M.A.S.S. Update
DIV 30 - Portland Cement Concrete

| Comment | Response |

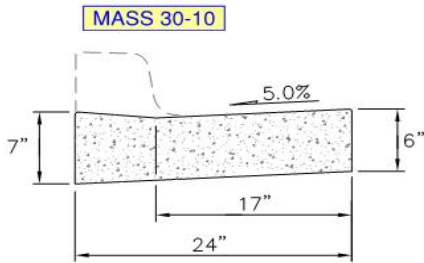
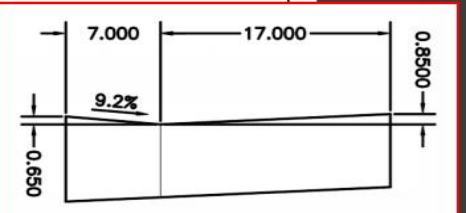
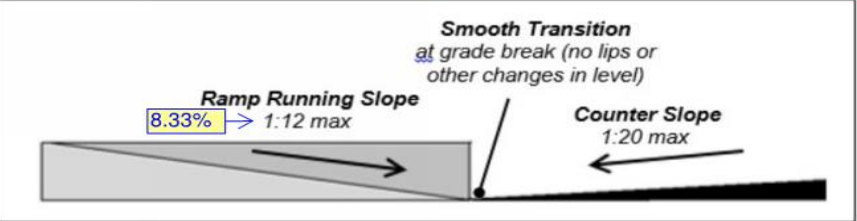
| Comment | Response |
|---|---|
| Replace all of these with the DOT profiles. The DOT profiles are very similar, but slightly different. Also, add the landscape curb detail that Parks uses. | P.C.C. Curb and Gutter Type 1A revised similar to AKDOT&PF to meet ADA Standards. Landscape curb is project specific , will not be addressed in M.A.S.S. |

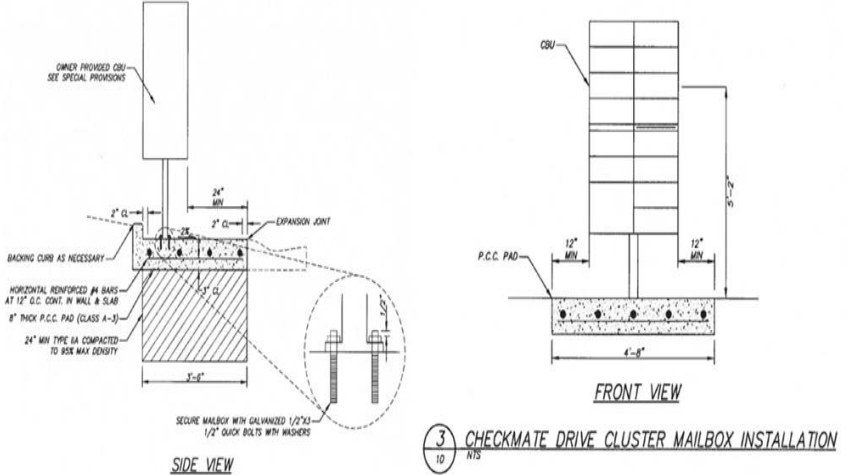
| Comment | Response |
|---|--|
| <p>On MASS 30-10 the PCC Curb and Gutter Type 1A appears to direct contractors to build a non ADA compliant slope within the curb. The detail does not give a slope for the bottom of the curb, but if the gutter slope is used it gives a 9.2% slope exceeding the maximum 8.3%. We recommend lengthening the curb portion similar to the DOT&PF curb detail. An image with the MASS detail, calculated slope, and ADA requirement is below.</p> <div style="display: flex; justify-content: space-around; align-items: flex-start;"> <div style="text-align: center;">  <p>MASS 30-10</p> <p>P.C.C. CURB AND GUTTER TYPE 1A (FOR USE IN CURB RAMPS)</p> </div> <div style="border: 2px solid red; padding: 5px;">  <p>MOA ADA CURB & GUTTER</p> </div> <div style="border: 2px solid red; padding: 5px;">  <p>DOT&PF ADA CURB & GUTTER</p> </div> </div> <div style="border: 1px solid blue; padding: 5px; margin-top: 10px;"> <p>Transition to Street From US Access Board</p> <p>§406.2</p>  <p>Smooth Transition at grade break (no lips or other changes in level)</p> <p>Ramp Running Slope 8.33% → 1:12 max</p> <p>Counter Slope 1:20 max</p> </div> | <p>P.C.C. Curb and Gutter Type 1A revised to meet ADA Standards.</p> |
